RE: St. Lucie Units 1 and 2  
Docket Nos. 50-335 and 50-389  
Response to NRC Request for Additional Information  
Generic Letter 96-06 Waterhammer Issues

**Attachment**  
**St. Lucie Units 1 and 2 Response**  
**NRC Request for Additional Information Dated August 1, 2003**  
**Regarding GL 96-06 Waterhammer Issues**

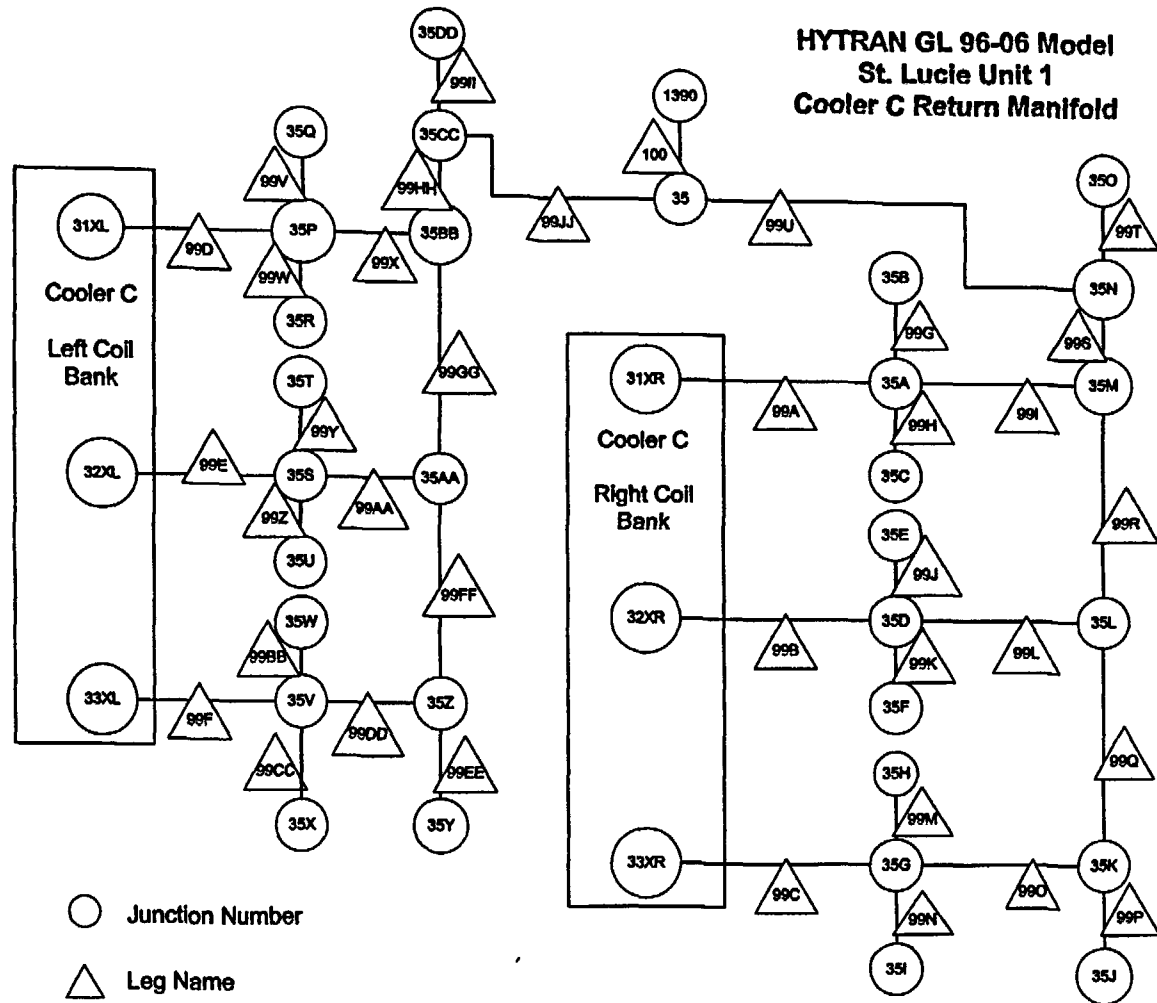
*NRC Question 1 - Page 2 of the March 13, 2003, submittal discussed benchmark testing of Component Cooling Water (CCW) system pump coastdown and recovery following restart. Provide a comparison between these tests to a postulated loss of offsite power (LOOP) event at St. Lucie. Provide comparisons of steam formation within the CCW piping, number of pumps starting, maximum flow rates within the system after pump restart and waterhammer produced. Also, identify the location of the test section, discussed on page 3, relative to the CCW pumps and the containment coolers.*

Benchmark test measurements were taken at pipe penetrations adjacent to the outside containment shield building wall. Relative locations to system components are shown on the following figure.

HYTRAN 96-06 Model - St. Lucie Unit 1

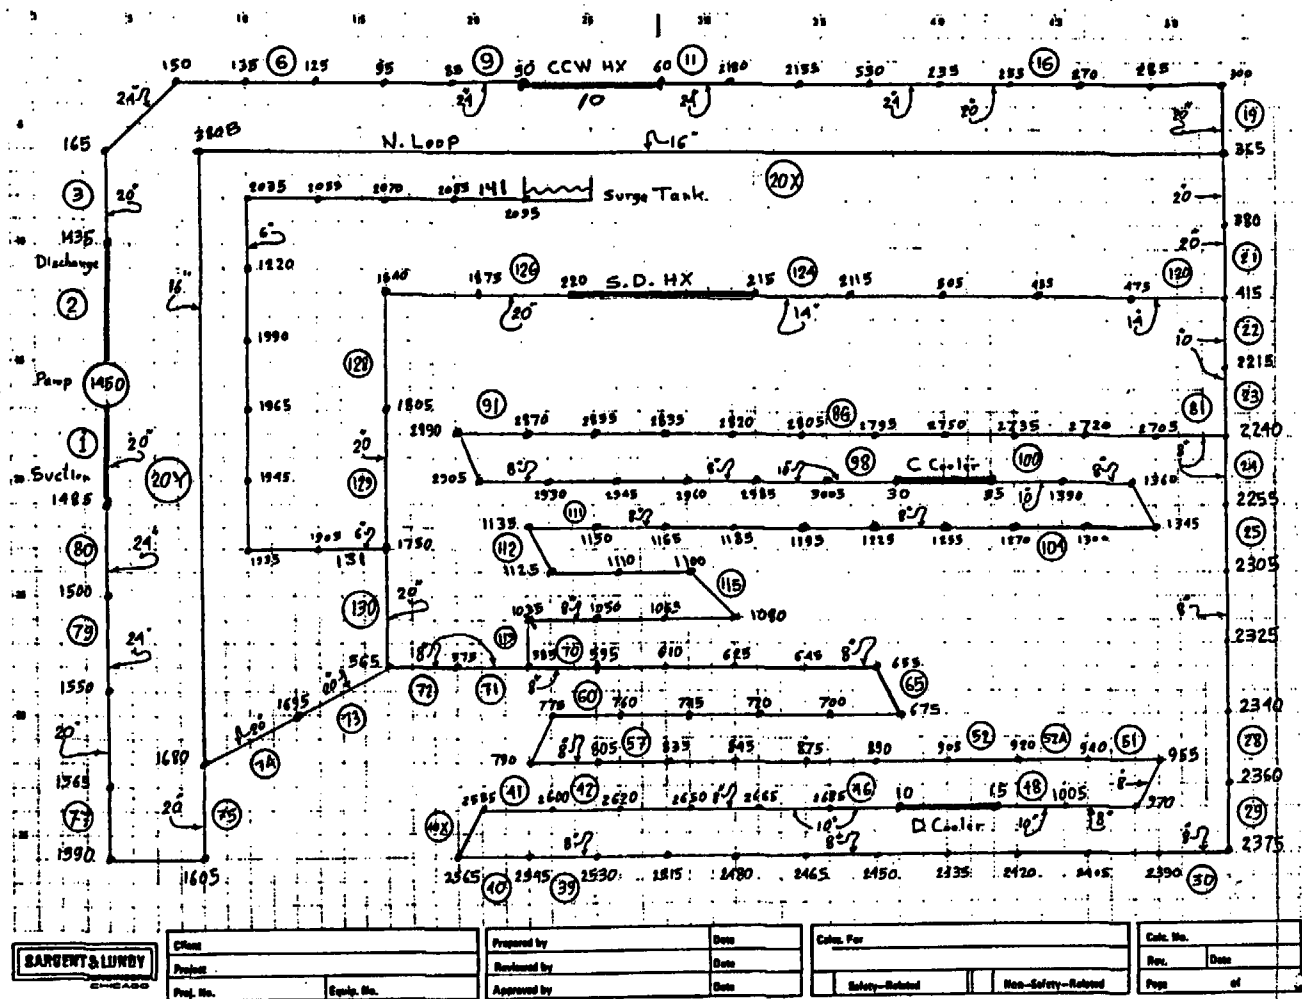
NRC Question 3- The submittal states that the HYTRAN code was used to predict peak pressure produced in the waterhammer analysis. The NRC staff has not previously reviewed the HYTRAN code for waterhammer analysis within CCW piping. Provide either the HYTRAN code for staff review, or provide an analysis of the most severe waterhammer postulated within the CCW piping using the Electric Power Research Institute (EPRI) methodology that the staff has approved. If you choose to apply the EPRI methodology rather than submitting the HYTRAN code for staff review, provide the following information:

The following Load Comparison Table compares RBM and HYTRAN/MOC maximum leg forces. The accompanying Node Point/Leg Sketches indicate the locations of the legs.

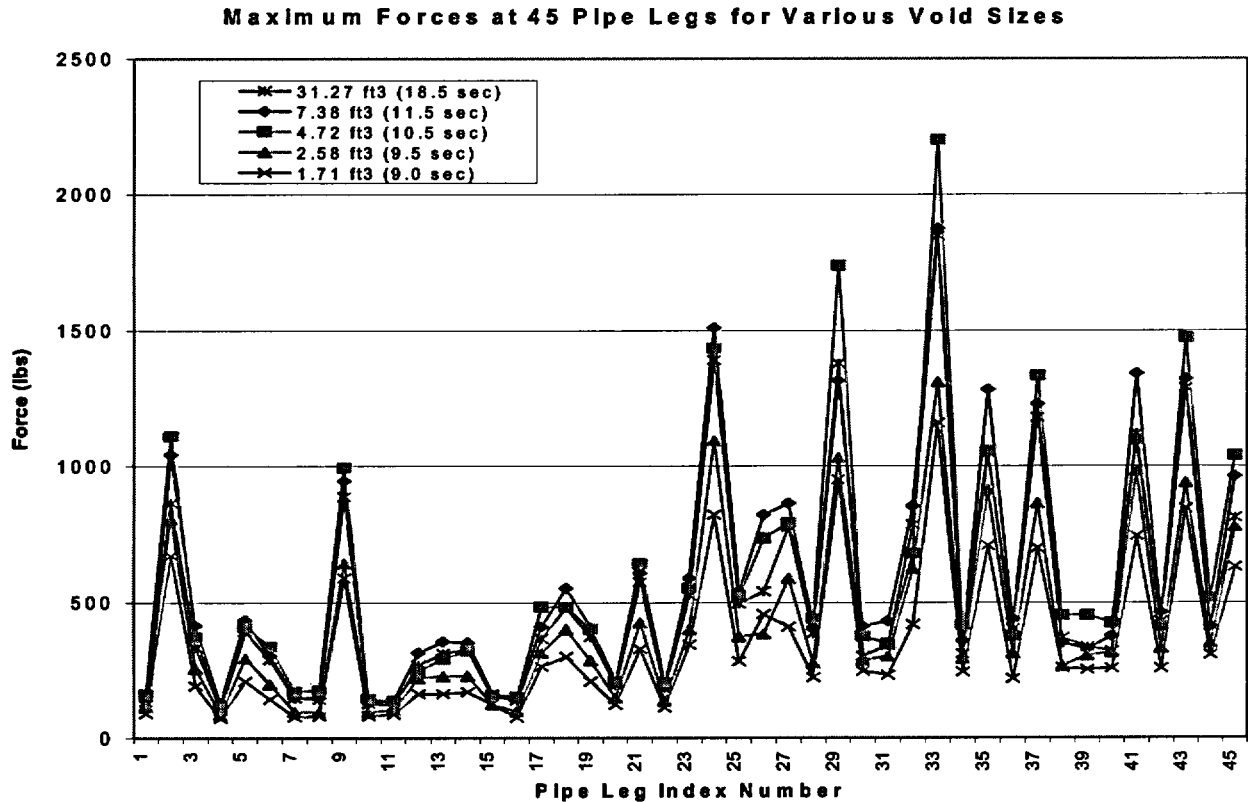
*NRC Question 8 - Page 11 of the submittal states that the loads and stresses are "not sensitive to void size." Explain.*

A parametric review was performed with respect to the affect of void size on maximum pipe segment loads for the 45 legs in the CFC return lines within the Unit 1 B CCW train for five arbitrary void volumes. The effect of void size on pipe segment loads is shown below. The results indicated that the loads were very small at low void size (1.71 ft<sup>3</sup>), increased as void size increased (2.58 ft<sup>3</sup> to 4.72 ft<sup>3</sup>), decreased slightly at 7.38 ft<sup>3</sup> and dropped off again at a void size of 31.37 ft<sup>3</sup>. The variance in the maximum loads between the analyzed case (7.38 ft<sup>3</sup>) and other void sizes reviewed ranged from 10% to 25%.
